ADDENDUM TO THE CONTRACT

**Downtown Fire Station Paving
Contract No. E15-092**

ADDENDUM NO.: ONE

DATE ADDENDUM ISSUED: September 5, 2014

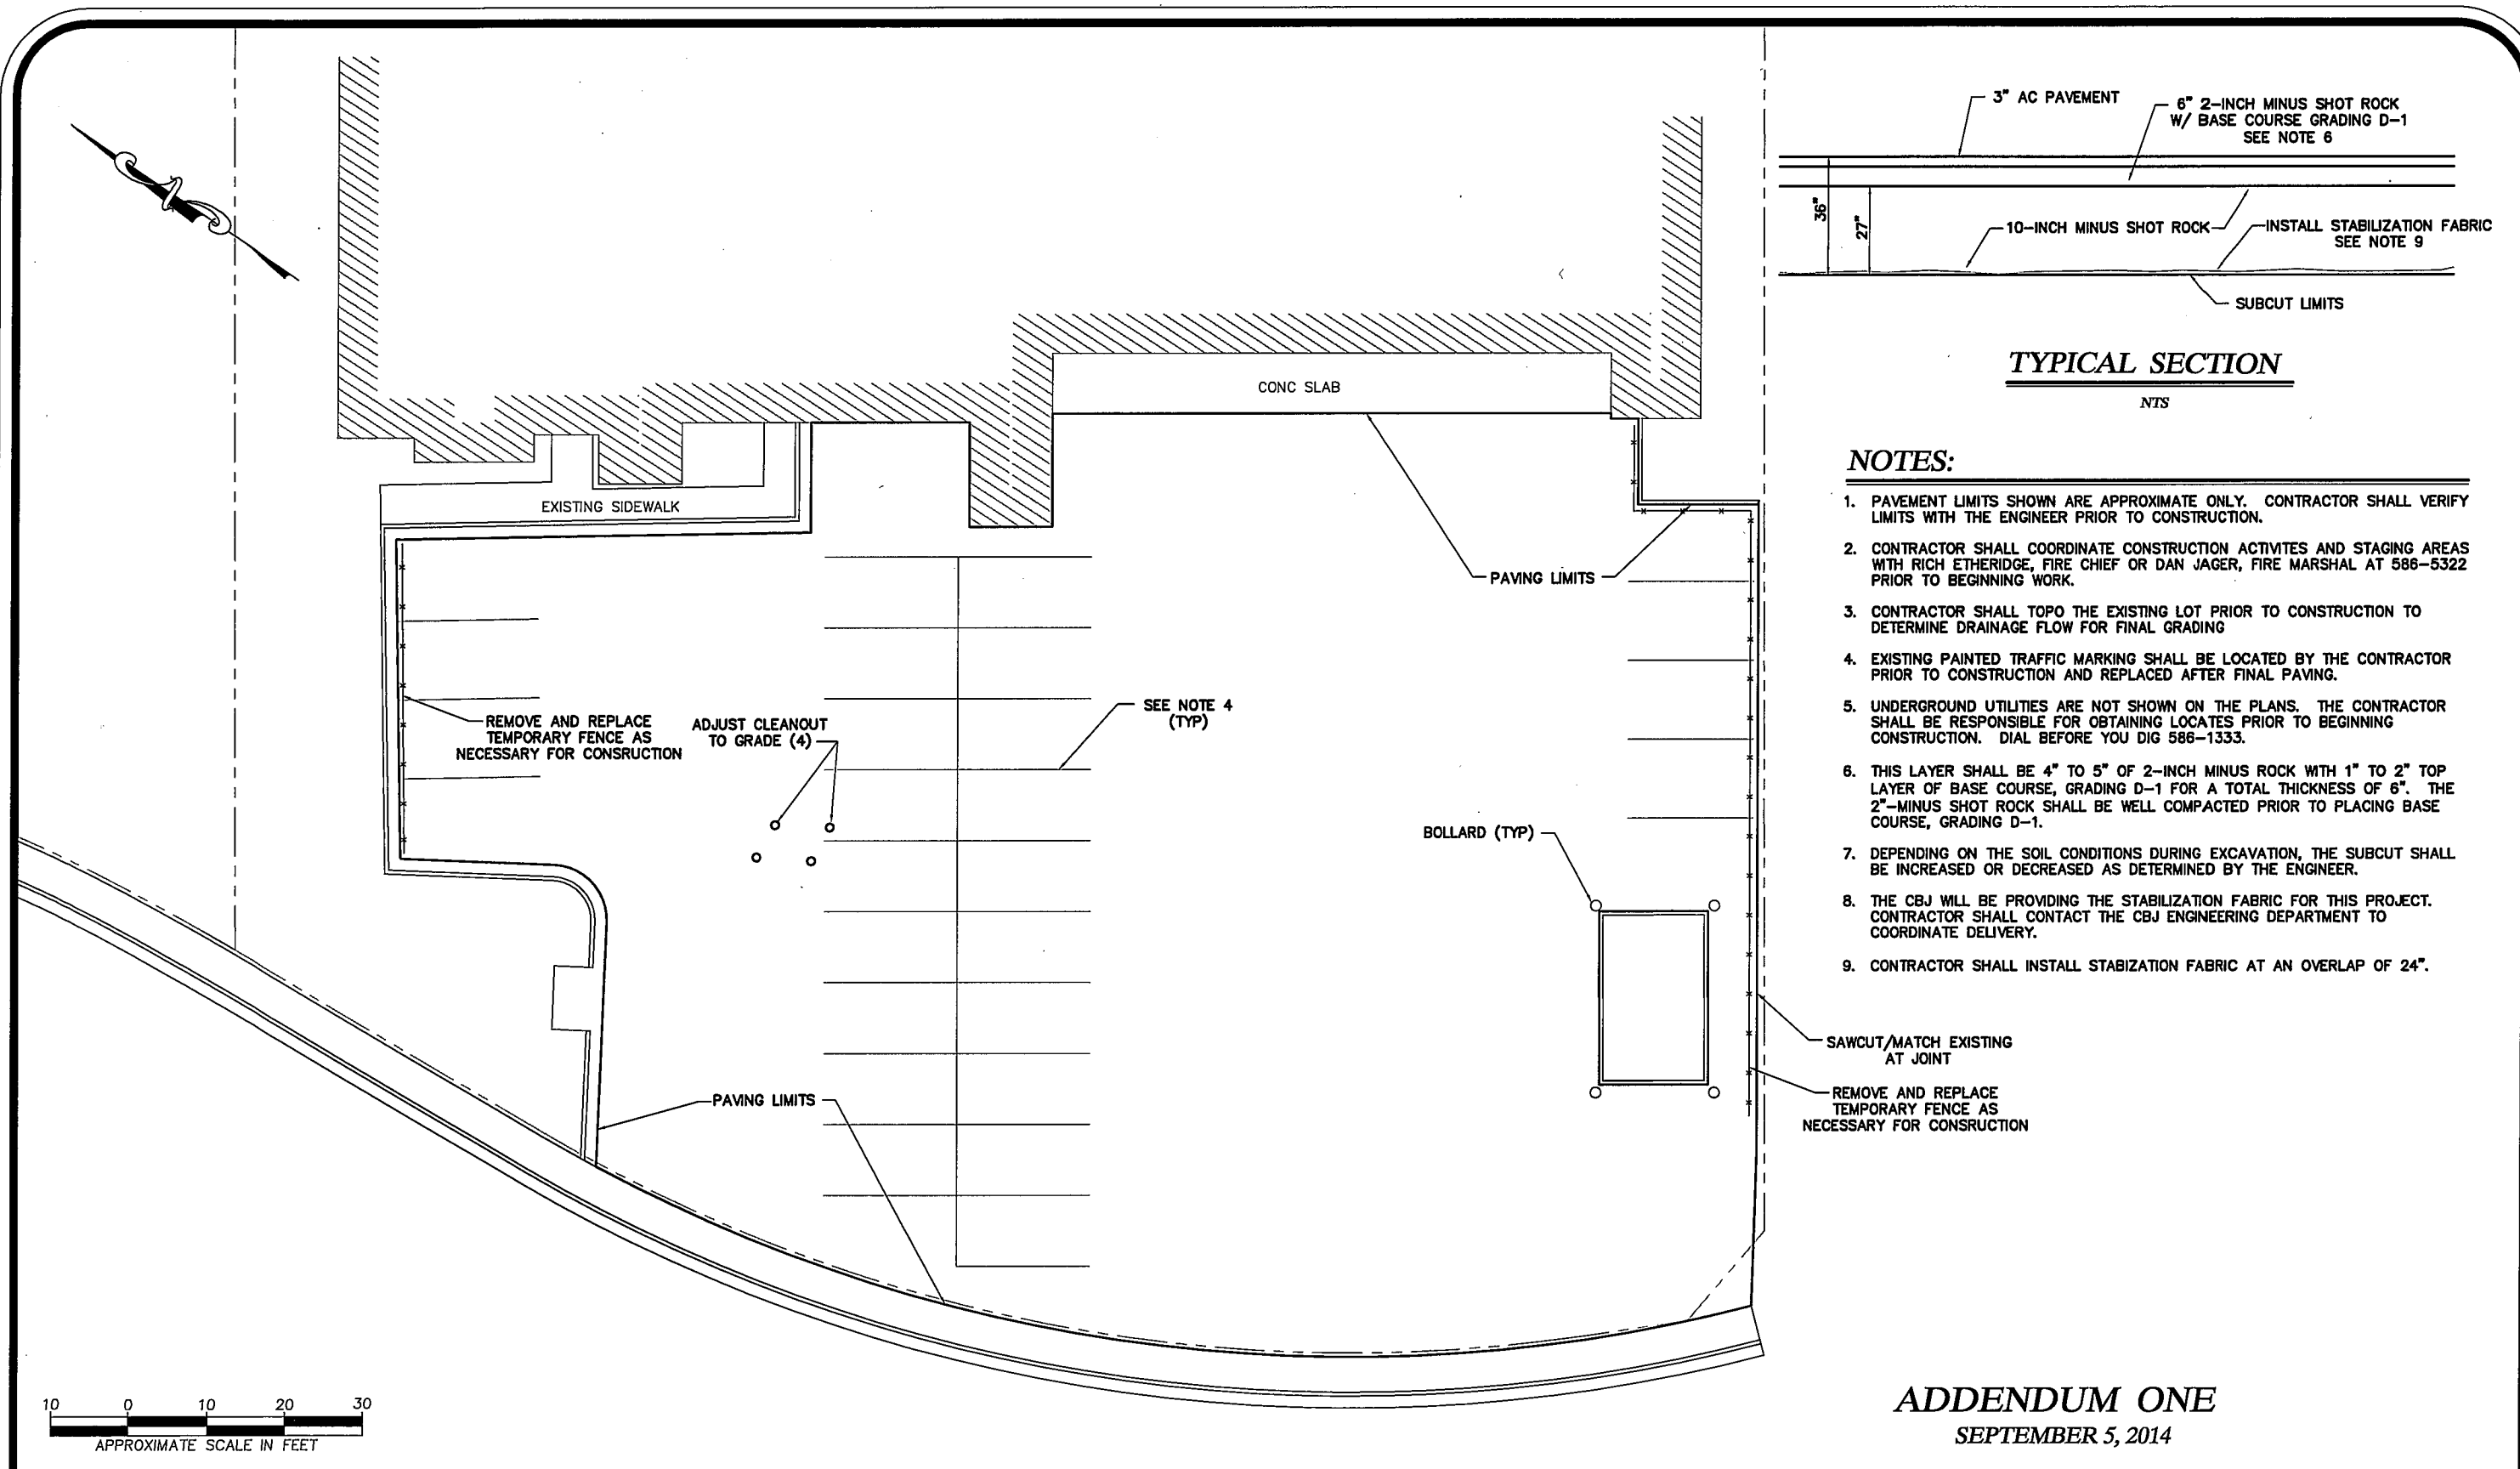
Item No. 4 *Delete and replace*, Sheet 2A PLAN & TYPICAL SECTION, with the attached Sheet 2A PLAN & TYPICAL SECTION, labeled Addendum No. 1

7. DEPENDING ON THE SOIL CONDITIONS DURING EXCAVATION, THE SUBCUT SHALL BE INCREASED OR DECREASED AS DETERMINED BY THE ENGINEER.
8. THE CBJ WILL BE PROVIDING THE STABILIZATION FABRIC FOR THIS PROJECT. CONTRACTOR SHALL CONTACT THE CBJ ENGINEERING DEPARTMENT TO COORDINATE DELIVERY.

9. CONTRACTOR SHALL INSTALL STABILIZATION FABRIC AT AN OVERLAP OF 24".
